BID # /PROJECT: Bid #22-23-02F Classroom Preparation for ViewSonics – Group 4
SUBJECT: Addendum #1

22-23-02F Classroom Preparation For ViewSonics - Group 4 Pathway Scope of Work

Portables Sleeving/Power Scope of Work

Cortez Elementary

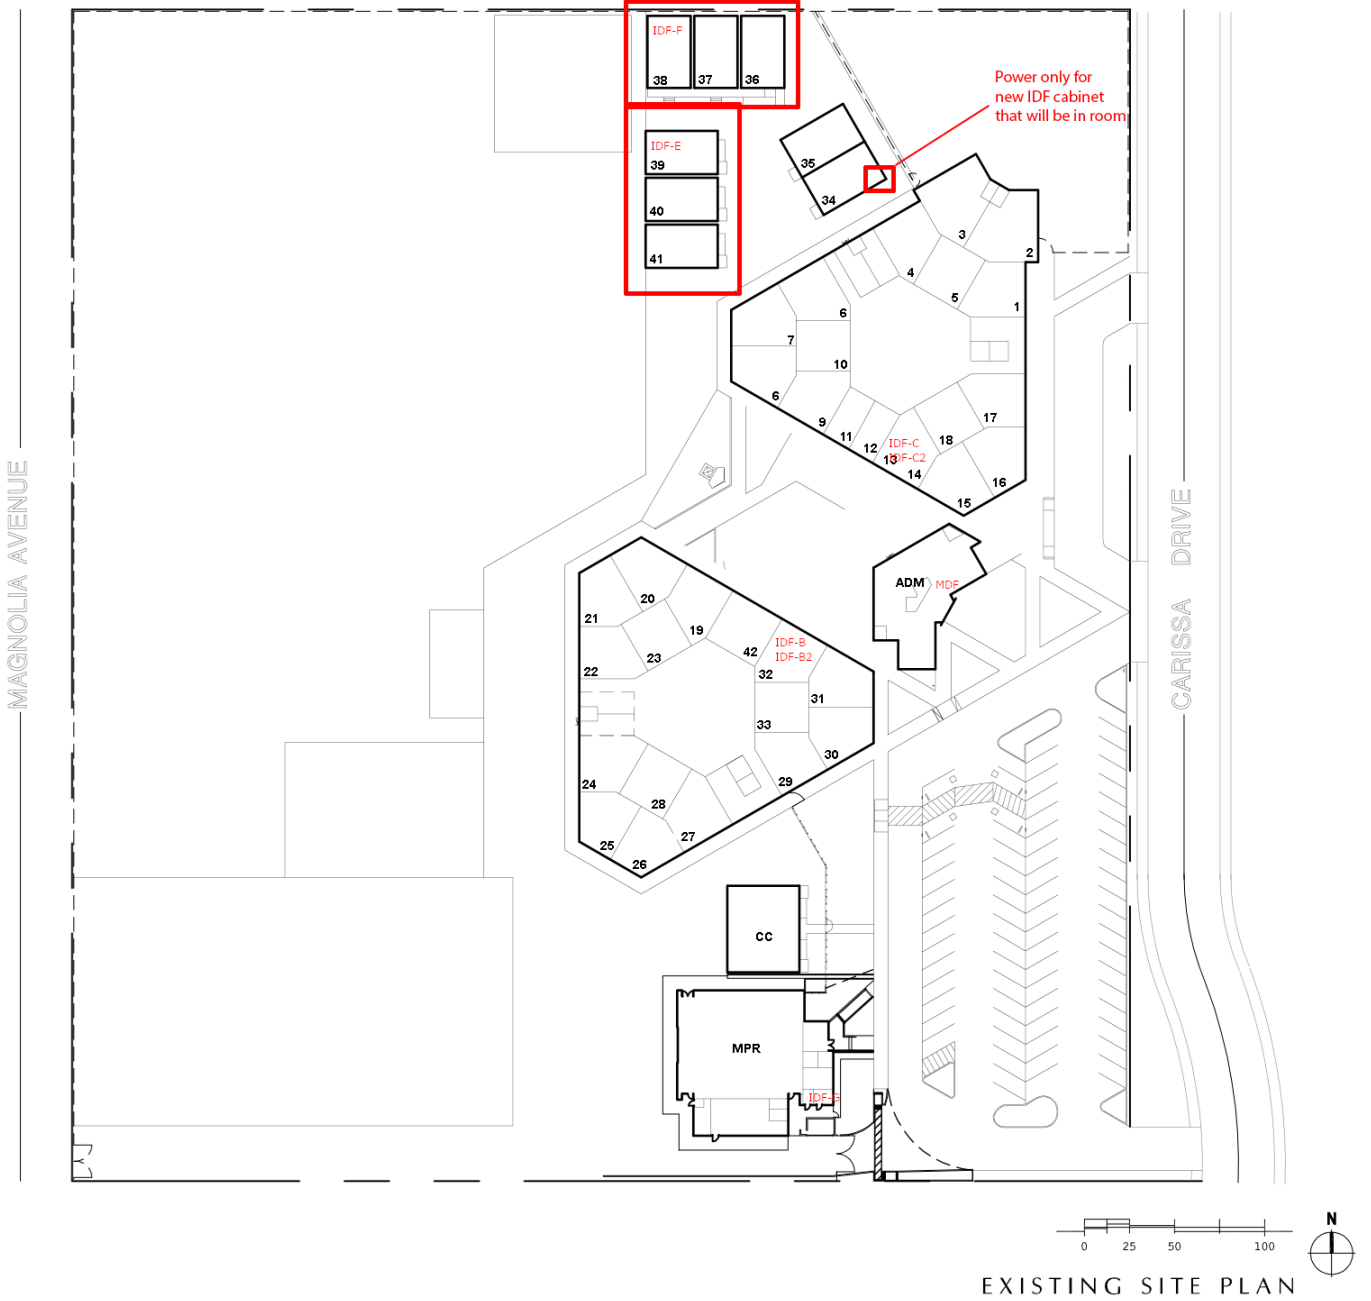
1. Provide and install 2" seal tight conduit pathways between the portable classrooms (1- per portable), Rooms 36-37, 37-38, 39-40, 40-41, 34-35
2. Removing and reinstalling the wood protective skirting to gain access.
3. 2" wall penetrations (above ceiling), 2" seal tight, silicone sealant, connectors, supports above the ceiling space, and plastic bushings.
4. The sleeves shall be installed on the side of the portable towards the rear.
5. Install 2-gang 120v Power into new IDF cabinet that will be in Room 34. It is preferred it is on its own circuit. Verify final location with the district before installation.

Dickson Elementary

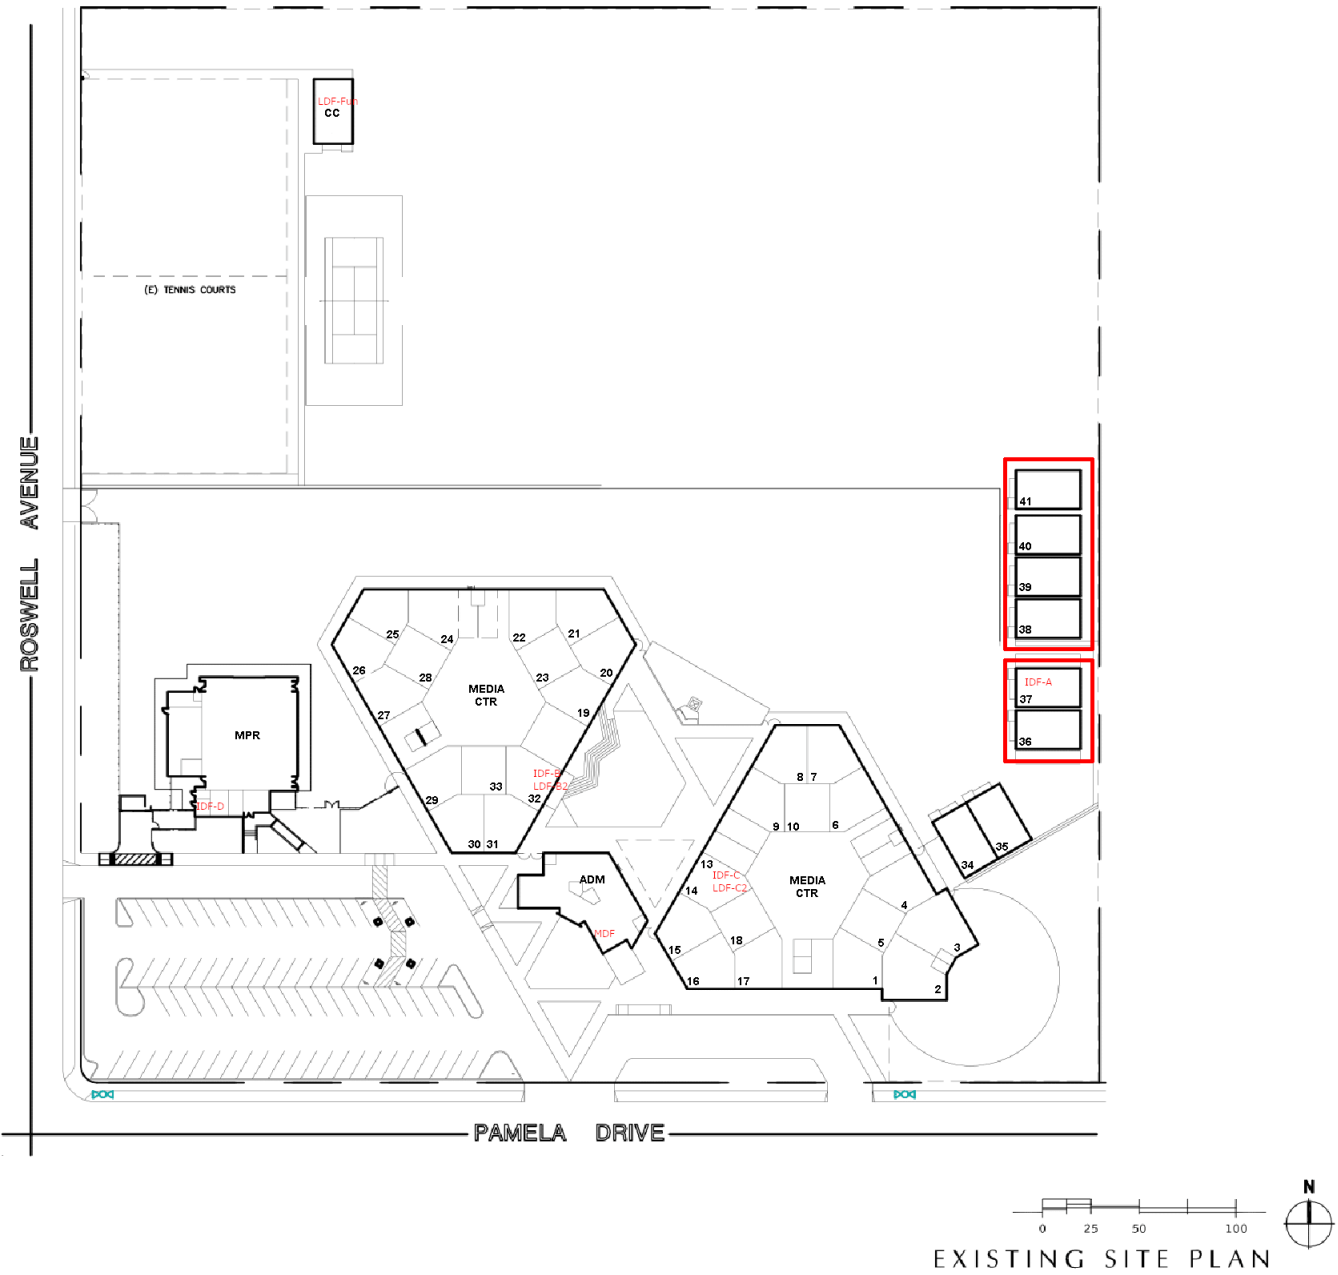
1. Provide and install 2" seal tight conduit pathways between the portable classrooms (1- per portable), Rooms 36-37, 38-39, 39-40, 40-41
2. Removing and reinstalling the wood protective skirting to gain access.
3. 2" wall penetrations (above ceiling), 2" seal tight, silicone sealant, connectors, supports above the ceiling space, and plastic bushings.
4. The sleeves shall be installed on the side of the portable towards the rear.

Don Lugo High School

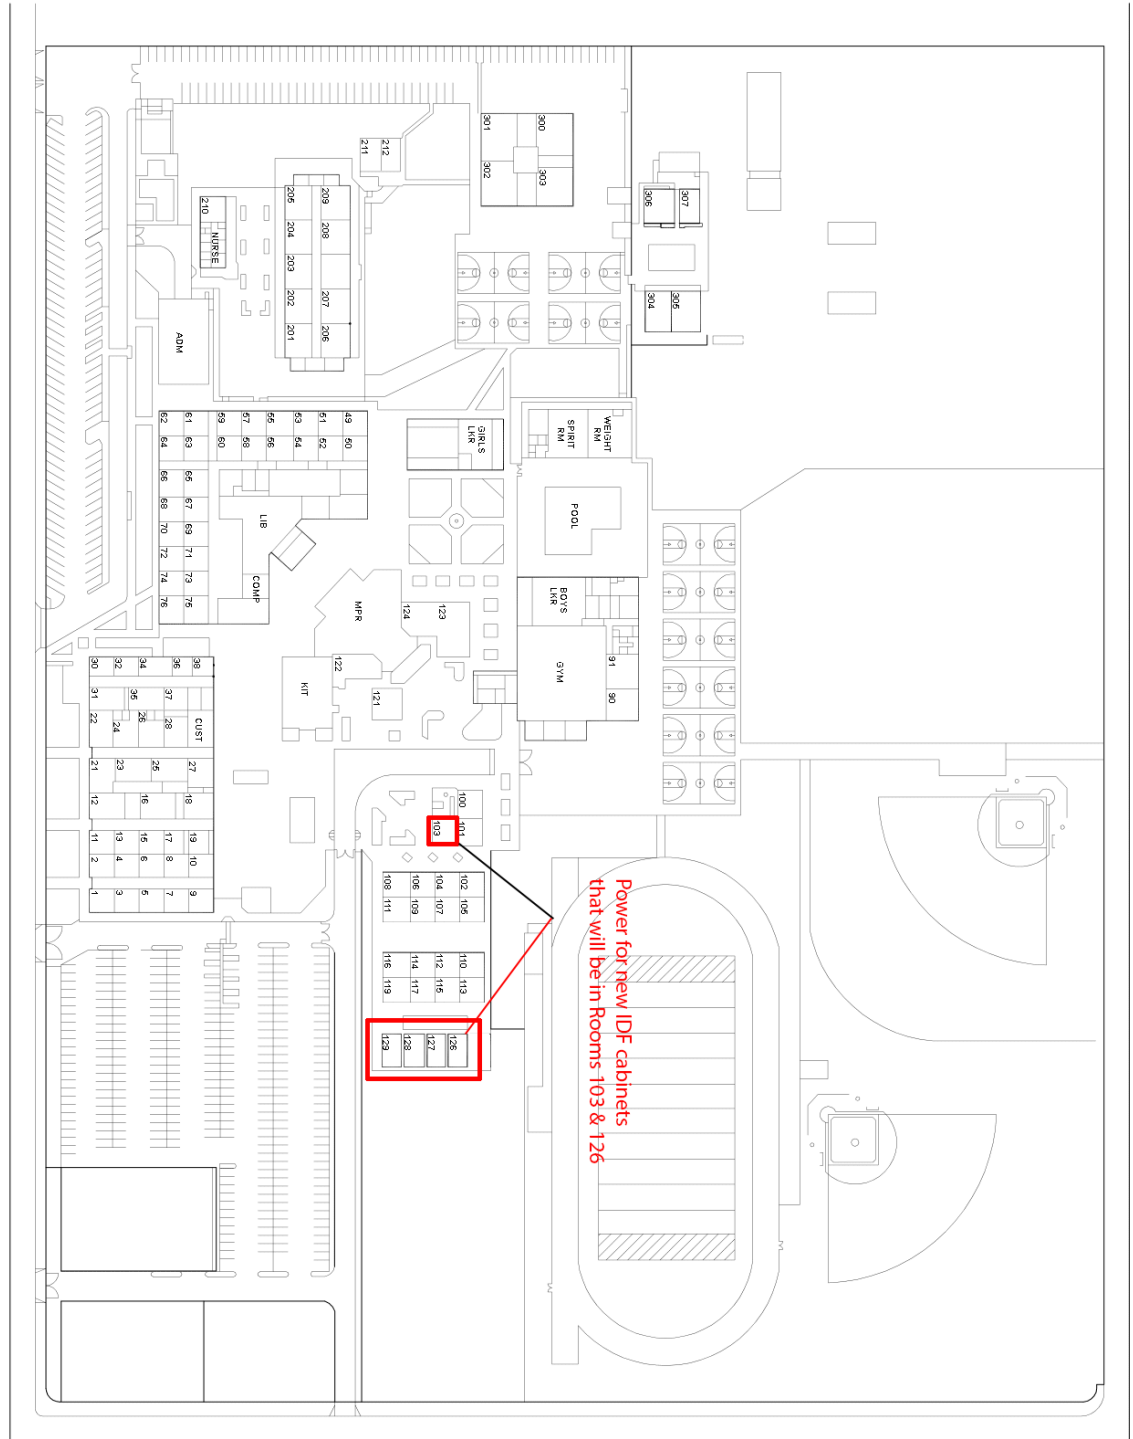
1. Provide and install 2" seal tight conduit pathways between the portable classrooms (1- per portable), rooms 126-127, 127-128, 128-129,
2. Removing and reinstalling the wood protective skirting to gain access.
3. 2" wall penetrations (above ceiling), 2" seal tight, silicone sealant, connectors, supports above the ceiling space, and plastic bushings.
4. The sleeves shall be installed on the side of the portable towards the rear.
5. Install 2-gang 120v Power into new IDF cabinet that will be in Rooms 103 and 126. It is preferred it is on its own circuit. Verify final location with the District before installation.

Glenmeade Elementary

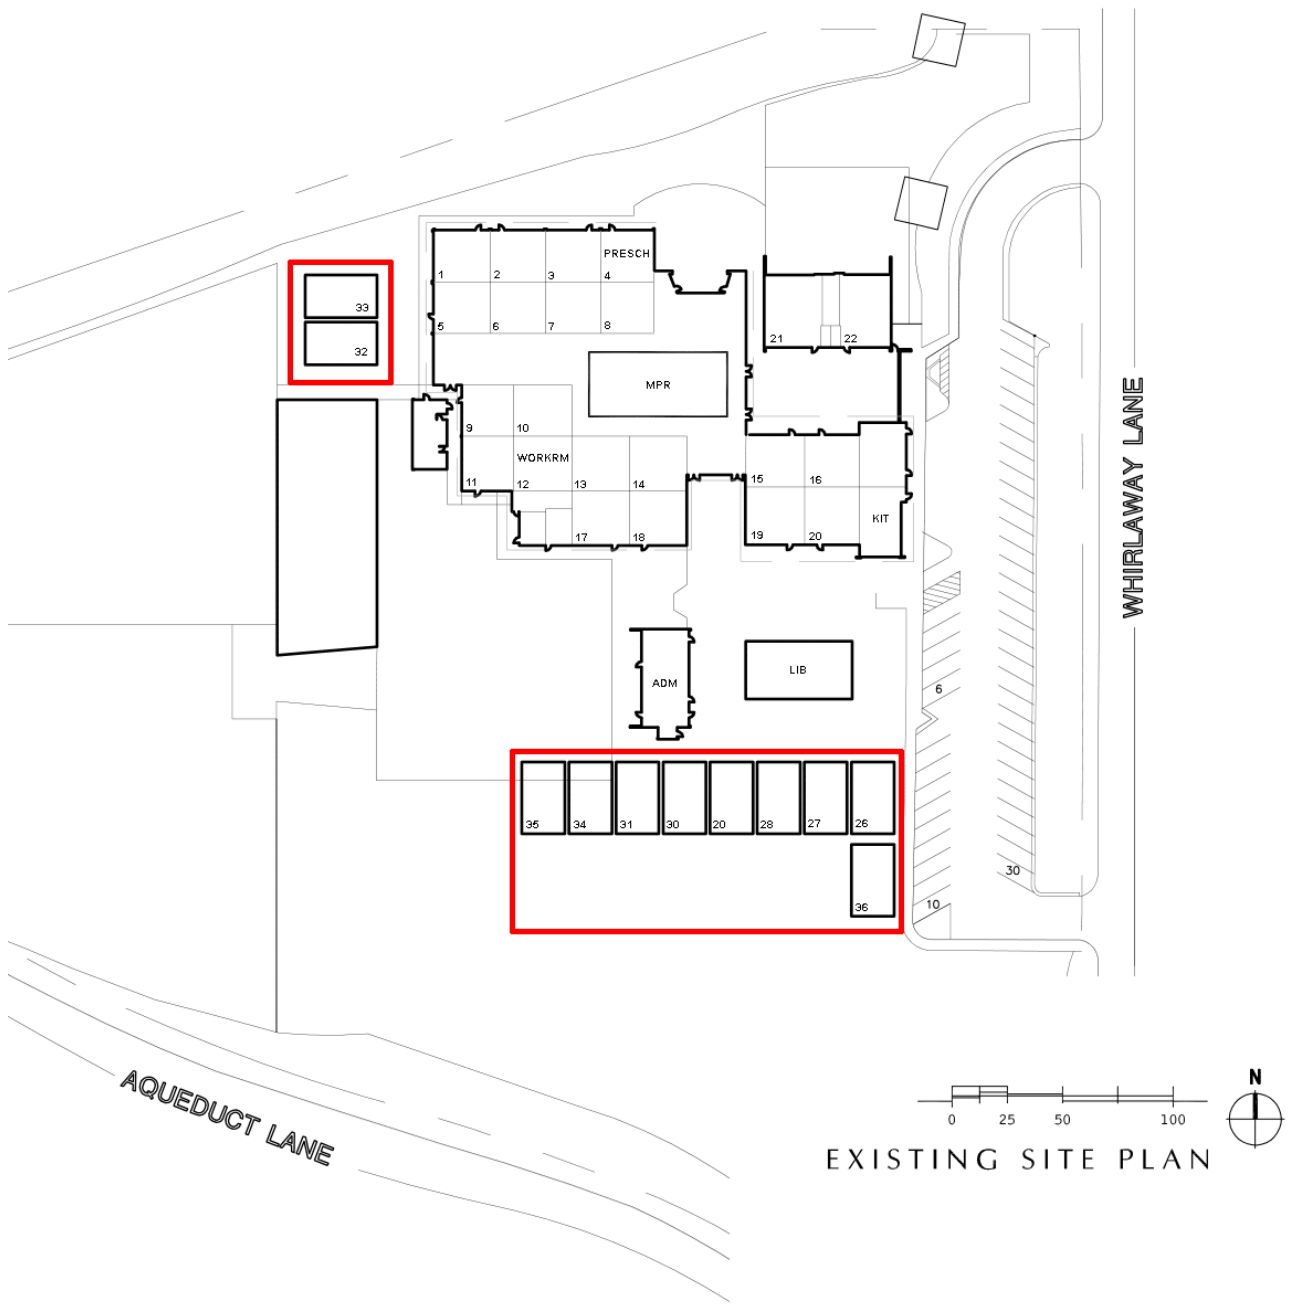
1. Provide and install 2" seal tight conduit pathways between the portable classrooms (1- per portable), Rooms 26-27, 27-28, 28-20, 20-30, 30-31, 31-34, 34-35, 32-33, 26-36
2. Removing and reinstalling the wood protective skirting to gain access.
3. 2" wall penetrations (above ceiling), 2" seal tight, silicone sealant, connectors, supports above the ceiling space, and plastic bushings.
4. The sleeves shall be installed on the side of the portable towards the rear.

Magnolia Junior High

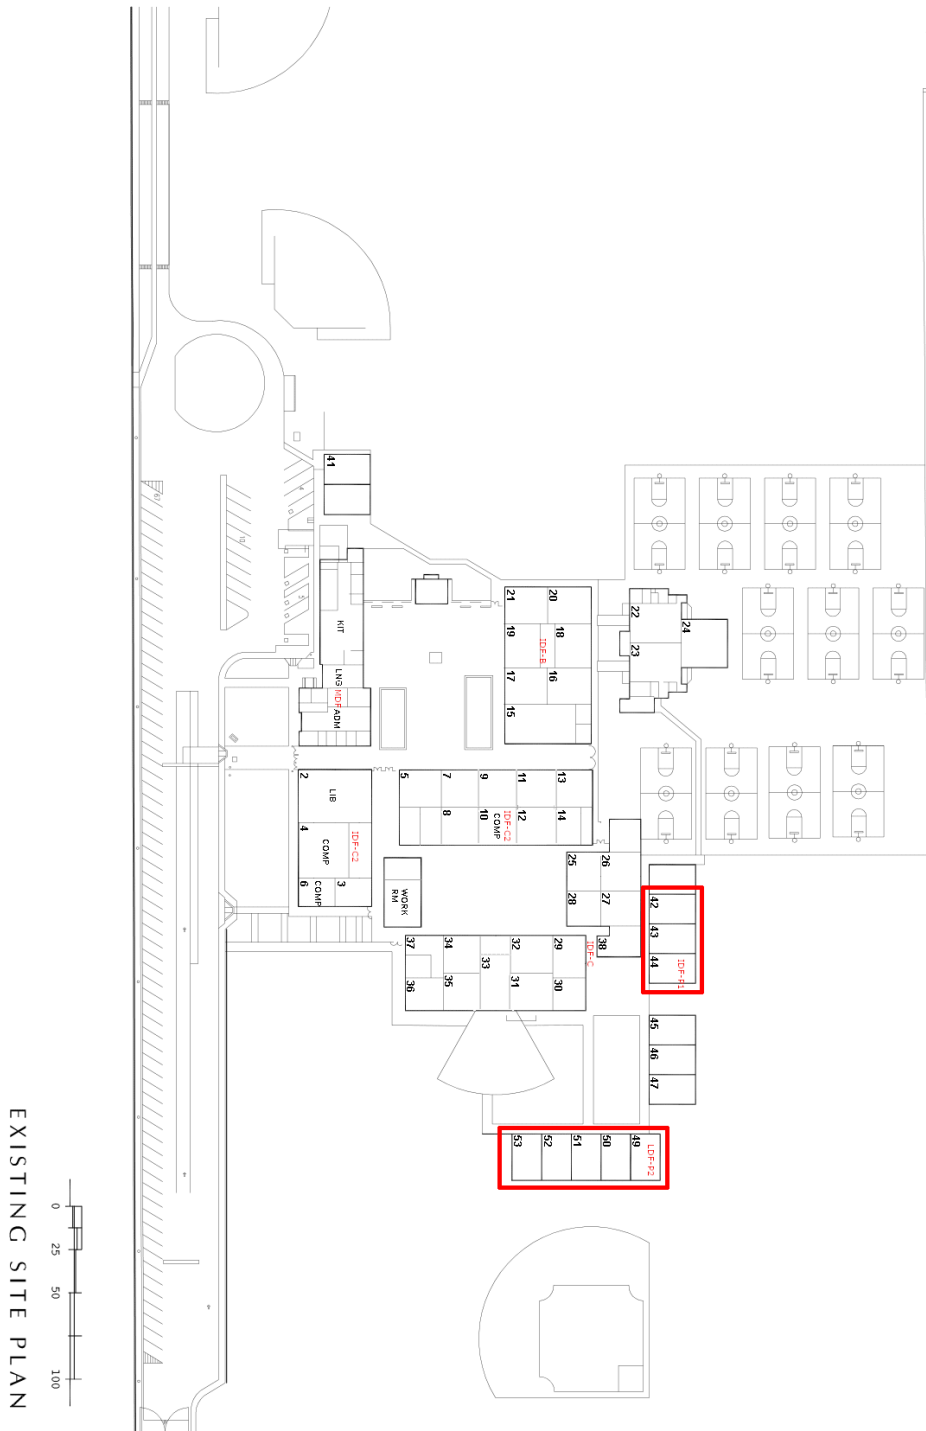
1. Provide and install 2" seal tight conduit pathways between the portable classrooms (1- per portable), Rooms 42-43, 43-44, 49-50, 50-51, 51-52, 52-53
2. Removing and reinstalling the wood protective skirting to gain access.
3. 2" wall penetrations (above ceiling), 2" seal tight, silicone sealant, connectors, supports above the ceiling space, and plastic bushings.
4. The sleeves shall be installed on the side of the portable towards the rear.

Rhodes Elementary School

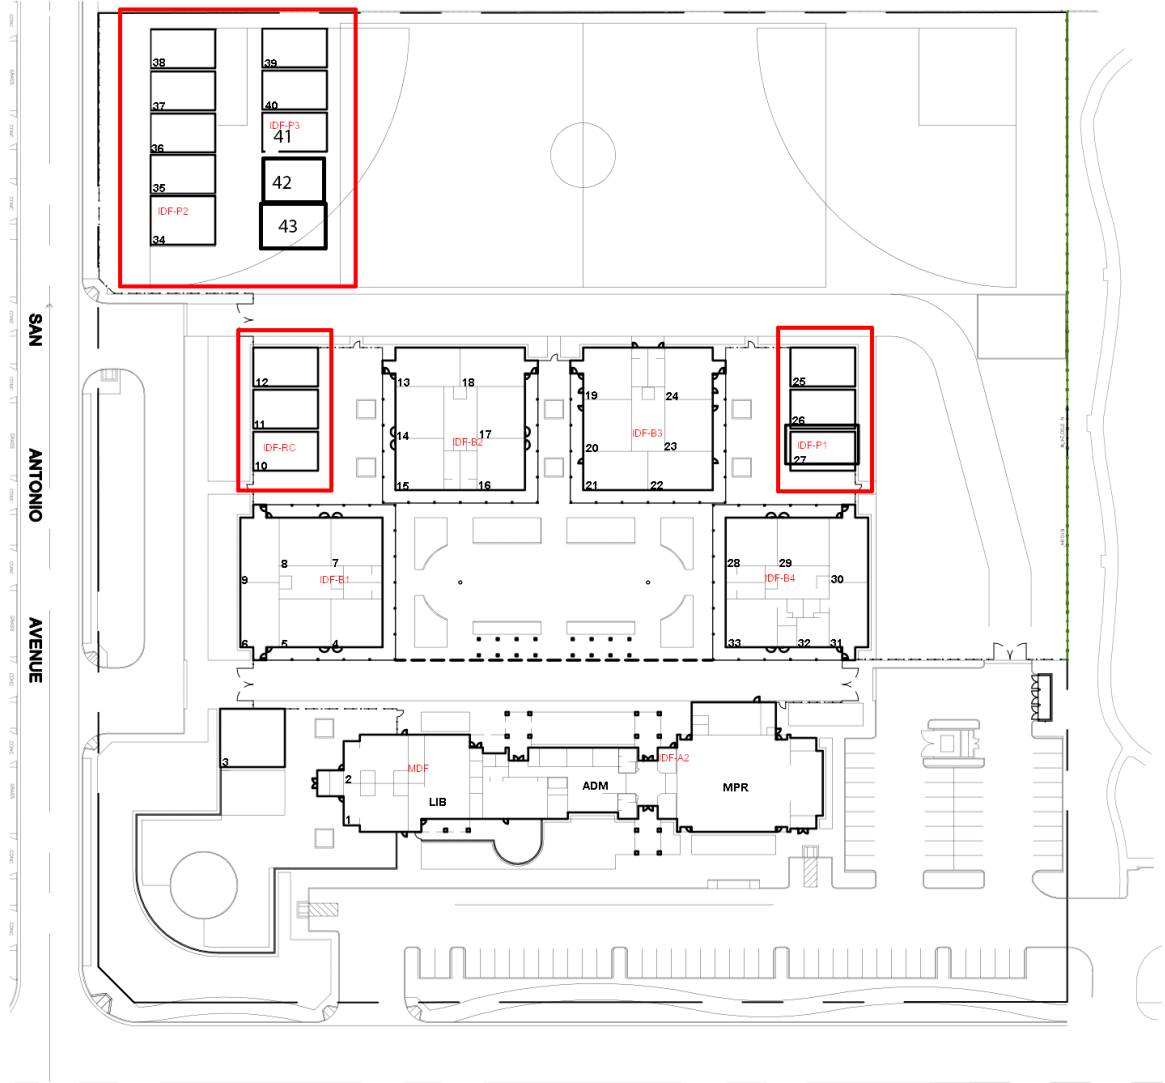
- Provide and install 2" seal tight conduit pathways between the portable classrooms (1- per portable), Rooms 10-11, 11-12, 25-26, 26-27, 34-35, 35-36, 36-37, 37-38, 39-40, 40-41, 41-42, 42-43
- Removing and reinstalling the wood protective skirting to gain access.
- 2" wall penetrations (above ceiling), 2" seal tight, silicone sealant, connectors, supports above the ceiling space, and plastic bushings.
- The sleeves shall be installed on the side of the portable towards the rear.

Wickman Elementary School

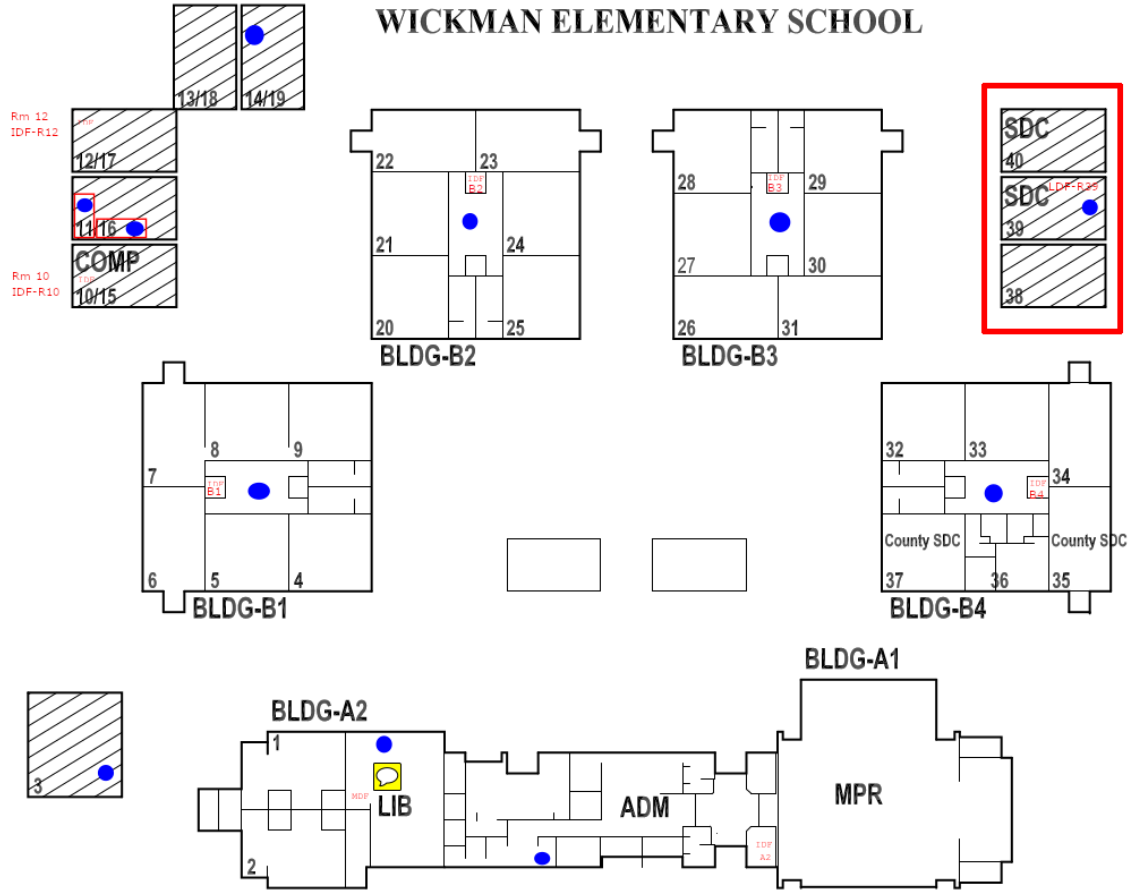
- Provide and install 2" seal tight conduit pathways between the portable classrooms (1- per portable), Rooms 38-39, 39-40
- Removing and reinstalling the wood protective skirting to gain access.
- 2" wall penetrations (above ceiling), 2" seal tight, silicone sealant, connectors, supports above the ceiling space, and plastic bushings.
- The sleeves shall be installed on the side of the portable towards the rear.
